Groundwater Transfer Review Summary Form

Transfer/PA # T- 14664 (temp)

Ground Water Review Form:

Application: T-14664

Well Location Map

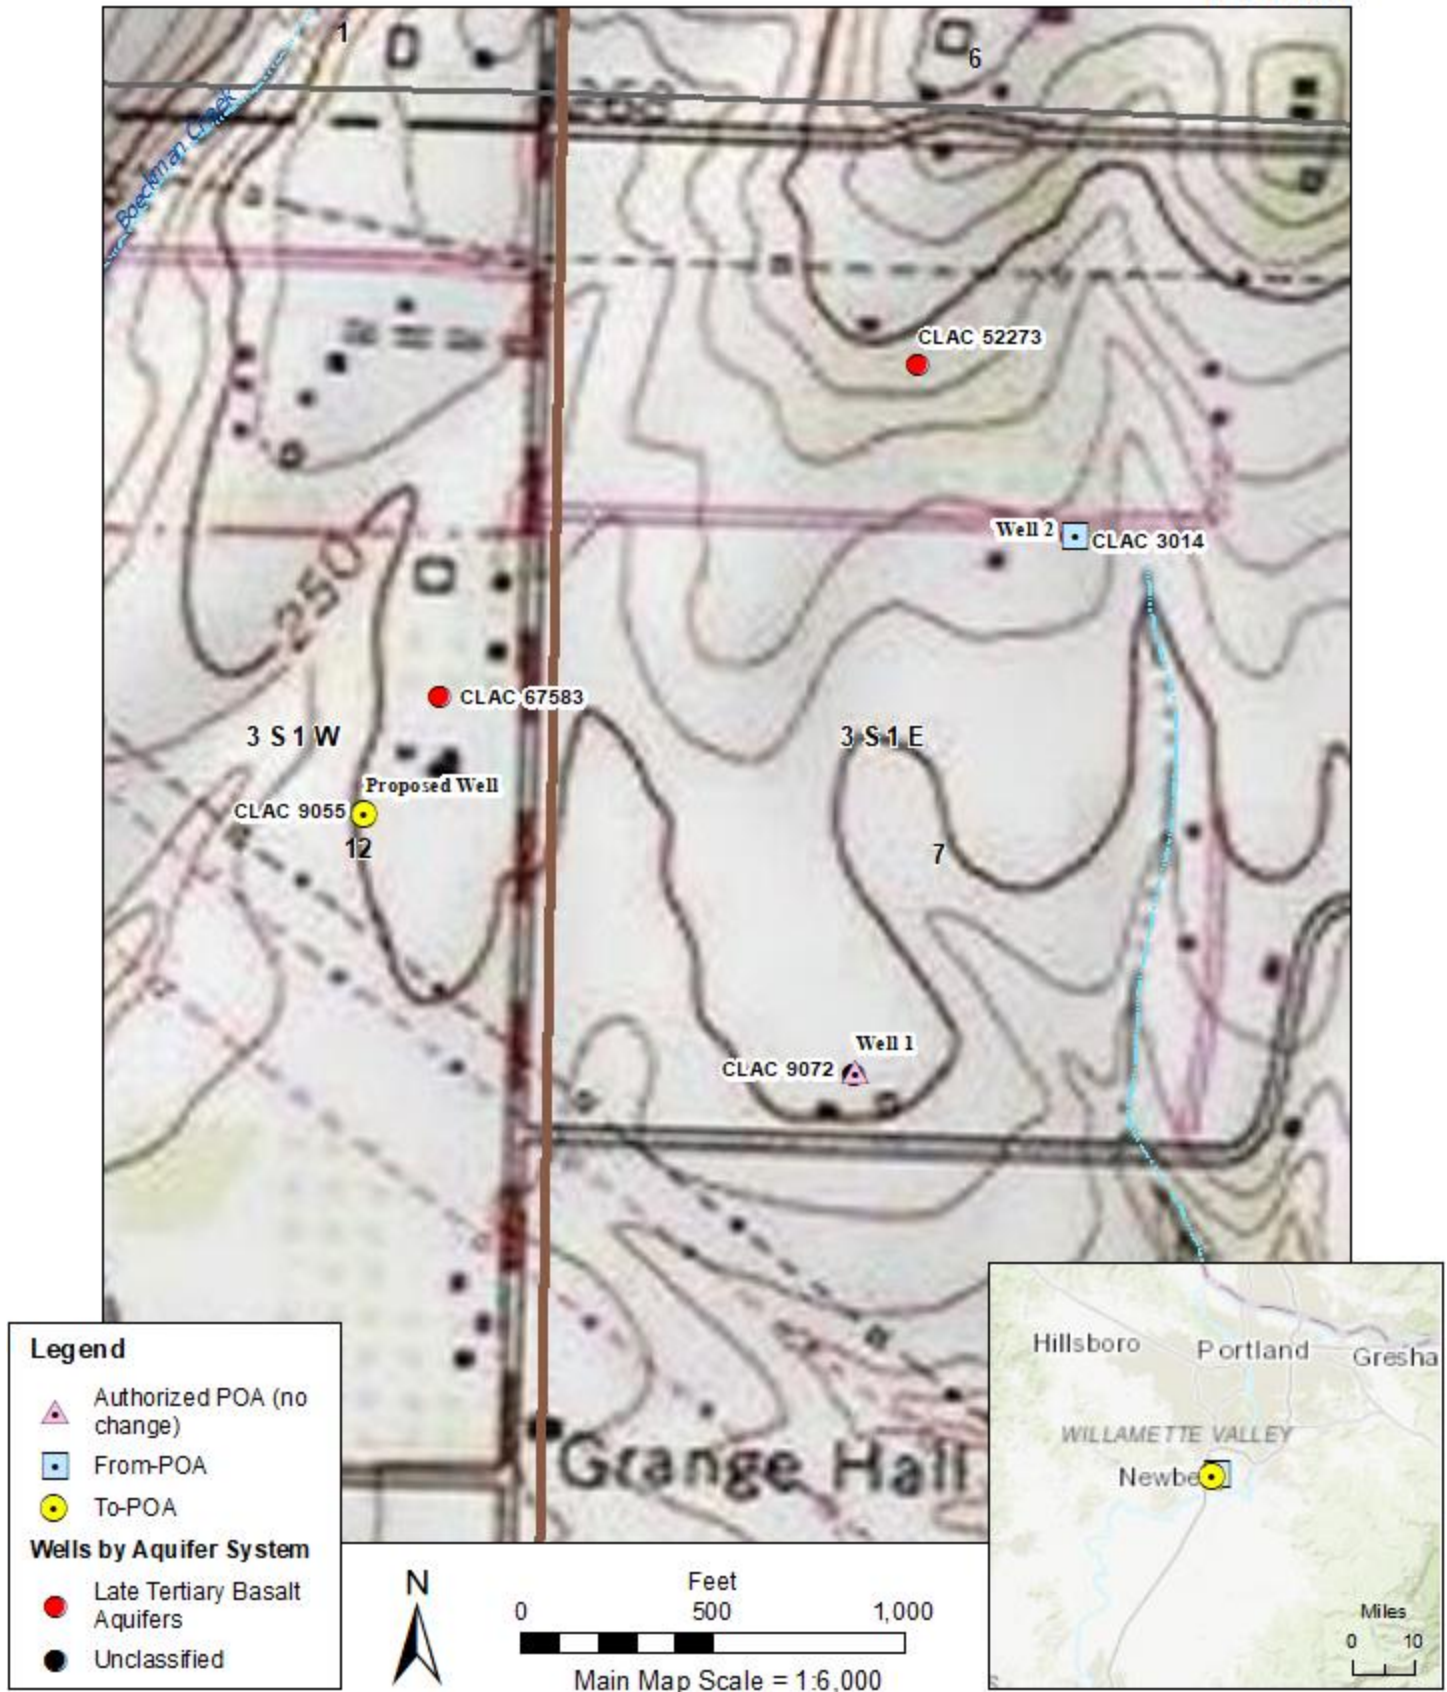
5. a) Will this proposed change, at its maximum allowed rate of use, likely result in an increase in interference with **another ground water right**?
☒ Yes ☐ No Comments: The proposed To-POA (CLAC 9055) is ~370 ft away from exempt domestic well CLAC 67583, whereas the From-POA (CLAC 3014) is ~1,700 ft away from CLAC 67583. The closer proximity of the To-POA will increase interference with CLAC 67583.

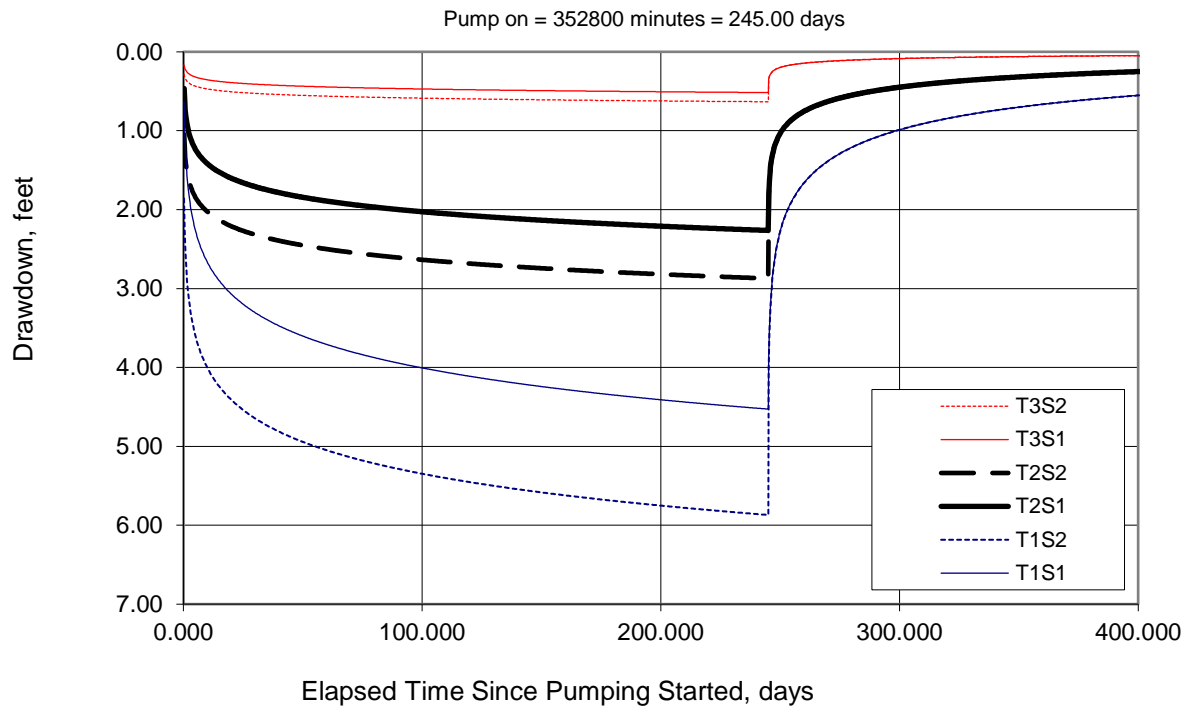
- b) If yes, would this proposed change, at its maximum allowed rate of use, likely result in another groundwater right not receiving the water to which it is legally entitled?
☐ Yes ☒ No If yes, explain: The potential interference with CLAC 67583 was analyzed using the Theis (1935) solution for drawdown in a confined aquifer (see attached Well Interference Analysis). Results of the analysis indicate that, at the proportional maximum rate of 0.135 cfs, the proposed change is unlikely to result in injury to CLAC 67583 or similar nearby wells.
